STATE OF MAINE  
DEPARTMENT OF TRANSPORTATION  
16 STATE HOUSE STATION  
AUGUSTA, MAINE 04333-0016

September 28, 2021  
Subject: Station 46 Bridge Replacement &  
Pleasant Cove Bridge Replacement  
State WINs: 023929.00 & 023929.01  
Location: **Woolwich**  
**Amendment No. 1**

SHEET NUMBER  
**1**  
OF 1

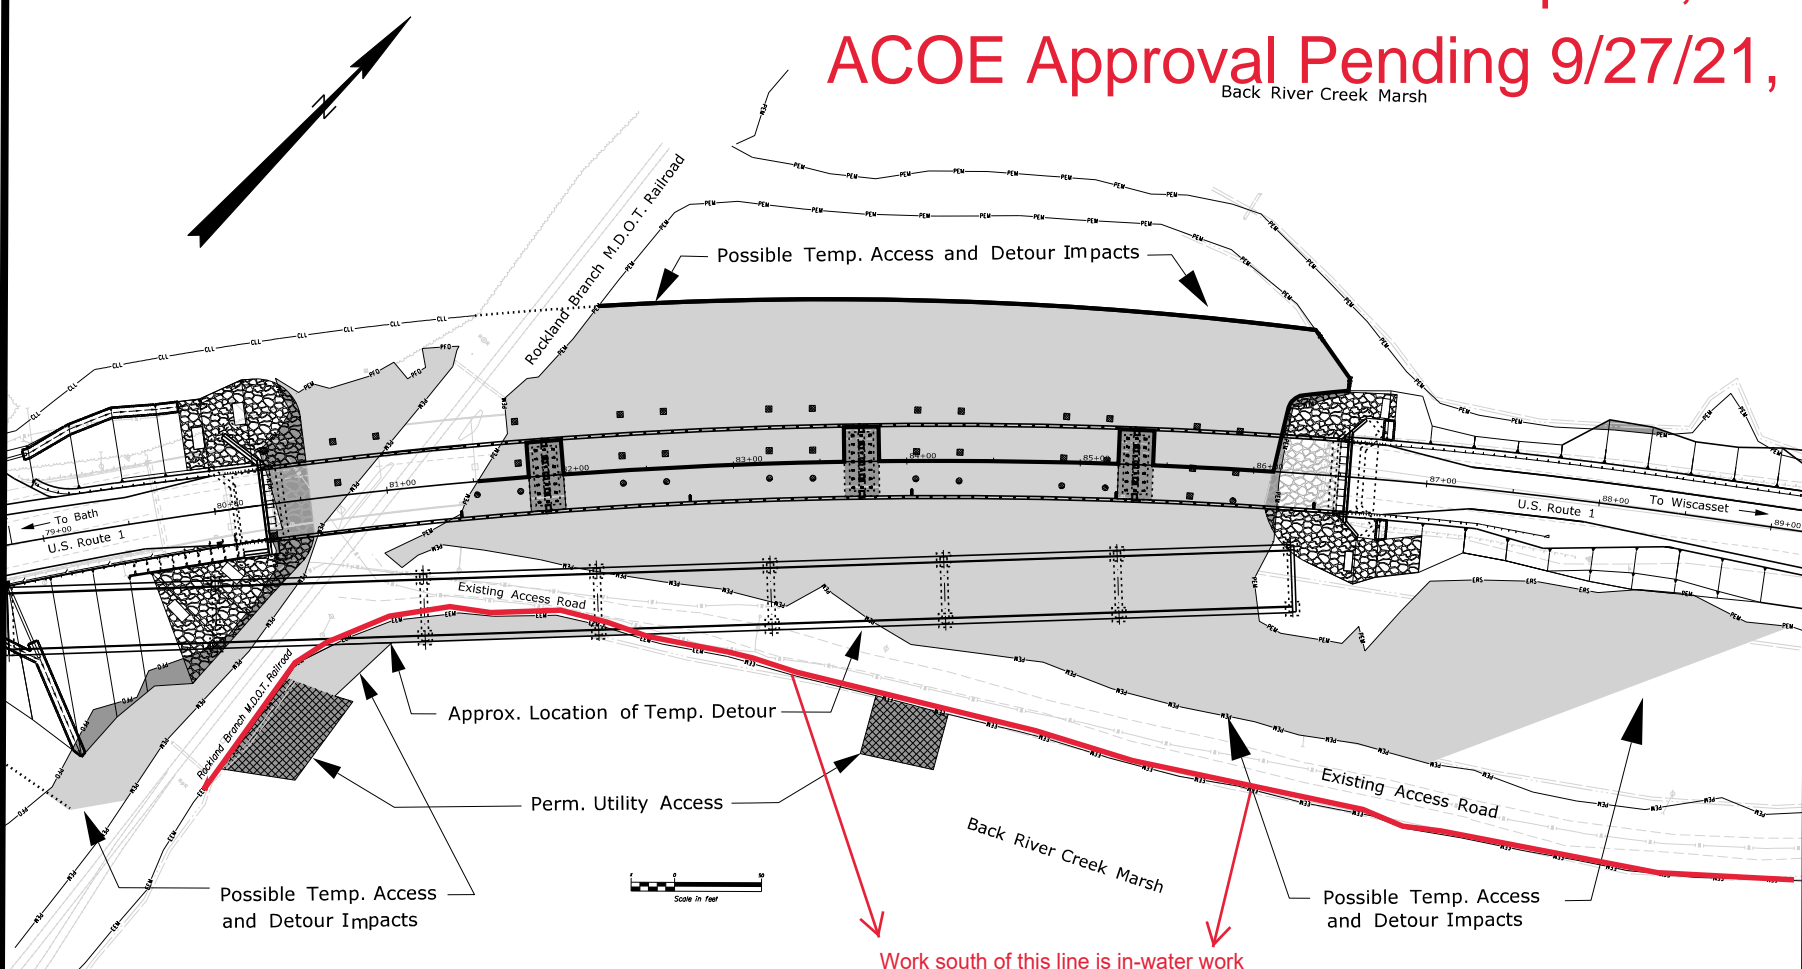
**Response:** Please see the attached schematic titled "Conceptual ACOE Impact Plan & defined in water work limits\_9/27/21" showing the temporary impact areas anticipated for access to Station 46 Bridge. The ACOE permit is anticipated by 10/6/21, at which point more clarification to these areas will be able to be provided.

- - PERM. EEM IMPACTS (Utility Access) = 3,750± S.F.
- - PERM. PEM IMPACTS (3 new piers) = 2,460± S.F.
- - PERM. PEM IMPACTS (slope cuts/fills) = 3,725± S.F.
- - TEMP. PEM IMPACTS (temp detour/access) = 108,290± S.F.
- - TEMP. EEM IMPACTS (temp detour/access) = 2,800± S.F.
- ■ - PERM. RESTORATION (existing pier removal) = 450± S.F.
